Staff Report & Recommendation

Design Review Board

SUBJECT: DRB23-0956
1901 Alton Road – Whole Foods

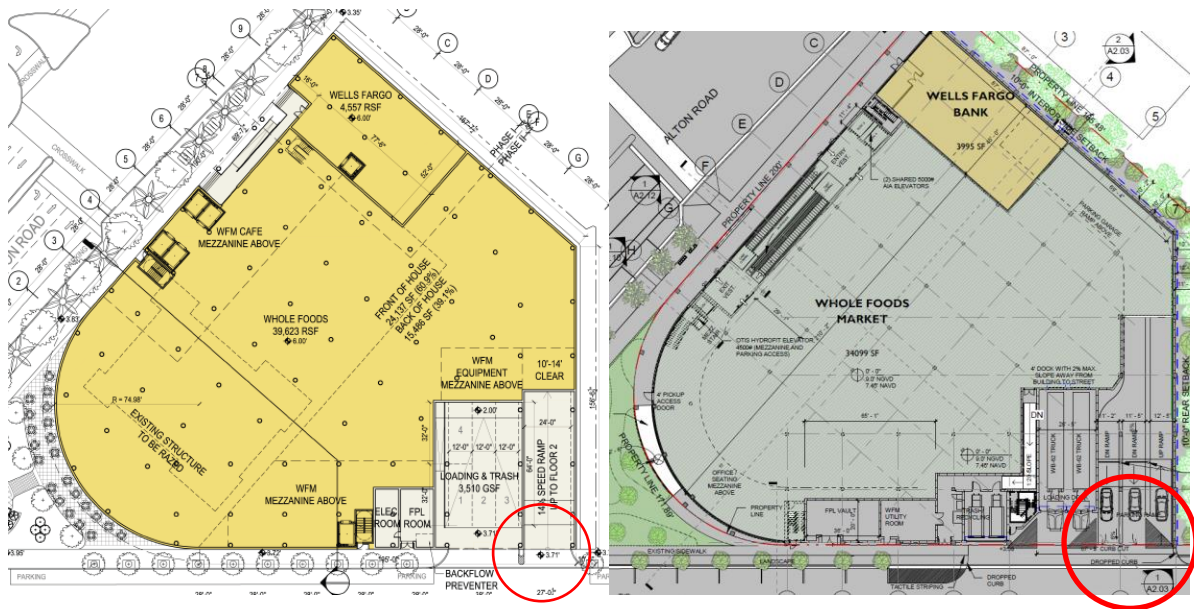
Staff compared the proposed site plan with the plan approved in 2015, and the following is noted:

2015 Approval:

Current proposal:

2 Car driveways
 3 Loading driveways

3 car driveways
 2 Loading driveways
 2 Trash compactors driveways

During the pre-application process, staff expressed serious reservations to the applicant regarding the driveway configuration proposed in comparison to the configuration approved in 2015 and recommended the removal of one of the car exit driveways, as well as reductions in the loading and trash compactor areas, to improve the pedestrian experience along 19th Street. Since the applicant has a surplus of parking on levels 3 to 4, double driveways could be accommodated on the second level to prevent queuing when exiting.

Since the final submittal, staff had a very productive discussion with the applicant regarding delivery, loading and refuse operations, traffic circulation within the building, as well as access from the driveways. The applicant believes that a 2-vehicle exit drive is critical for operations, given their expected traffic volume. In this regard, an important component of the proposed driveway and loading access points is pedestrian visibility for cars entering and exiting the drive and loading lanes. In this regard, the use of control gate arms in the proposed driveway exit lanes is paramount to providing safe pedestrian movement on the sidewalk, as they significantly slow exiting vehicles.

To accommodate control gate arms, the applicant believes a 2-lane exit option is needed in case there is a malfunction with one of the gate arms, or other delay. Although staff believes a one lane driveway exit is a better option, the 2-lane option proposed by the applicant, as part of other modifications to the 19th Street portion of the building, would be acceptable. The Conditional Use Permit from the Planning Board includes specific conditions regarding an automatic gate arm and other control mechanisms at the exit to slow vehicles as they exit the garage. Staff will provide a verbal update of the Planning Board's review of the application at the April 2, 2024 meeting. Lastly, the applicant has been able to minimize the frontage of the Utility room and FPL vault along 19th Street and will present these changes as part of their presentation to the Board.
